⚠ REVISED SHEET 7/14/2023 \* SPECIALTY ITEMS

**SUMMARY OF QUANTITIES  
I-57 AT PARNELL AVENUE**

**GENERAL PLAN & ELEVATION**  
**PARNELL AVENUE OVER INTERSTATE 57**  
**F.A.I. RTE. 57 - SECTION 2021-063-B**  
**COOK COUNTY**  
**STA. 30+00**  
**STRUCTURE NO. 016-2029**

REVISED ENTIRE SHEET 7/17/2023

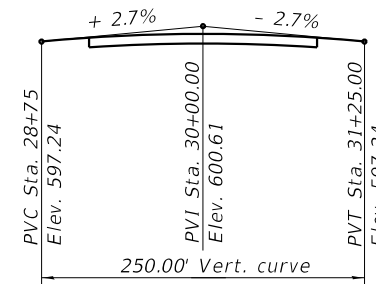
CODE NO.	ITEM	UNIT	TOTAL QUANTITY	CONSTRUCTION CODE	
				90% FED 10% STATE	90% FED 10% STATE
				BRIDGE	SAFETY - IDOT
				0013	0021
		SN 016-2029			
40604062	HOT-MIX ASPHALT SURFACE COURSE, IL-9.5, MIX "D", N70	TON	32	32	
42000070	PAVEMENT CONNECTOR (HMA) FOR BRIDGE APPROACH SLAB	SQ YD	80	80	
42400200	PORTLAND CEMENT CONCRETE SIDEWALK 5 INCH	SQ FT	1,138	1,138	
44000100	PAVEMENT REMOVAL	SQ YD	553	553	
44000500	COMBINATION CURB AND GUTTER REMOVAL	FOOT	385	385	
44000600	SIDEWALK REMOVAL	SQ FT	1,792	1,792	
44213200	SAW CUTS	FOOT	451	451	
50101500	REMOVAL OF EXISTING SUPERSTRUCTURES	EACH	1	1	
50102400	CONCRETE REMOVAL	CU YD	37.6	37.6	
50104000	BRIDGE RAIL REMOVAL	FOOT	230	230	
50157300	PROTECTIVE SHIELD	SQ YD	679	679	
50200100	STRUCTURE EXCAVATION	CU YD	122.8	122.8	
50300225	CONCRETE STRUCTURES	CU YD	107.2	107.2	
50300255	CONCRETE SUPERSTRUCTURE	CU YD	583.4 <del>504.8</del>	583.4 <del>504.8</del>	⚠
50300260	BRIDGE DECK GROOVING	SQ YD	957	957
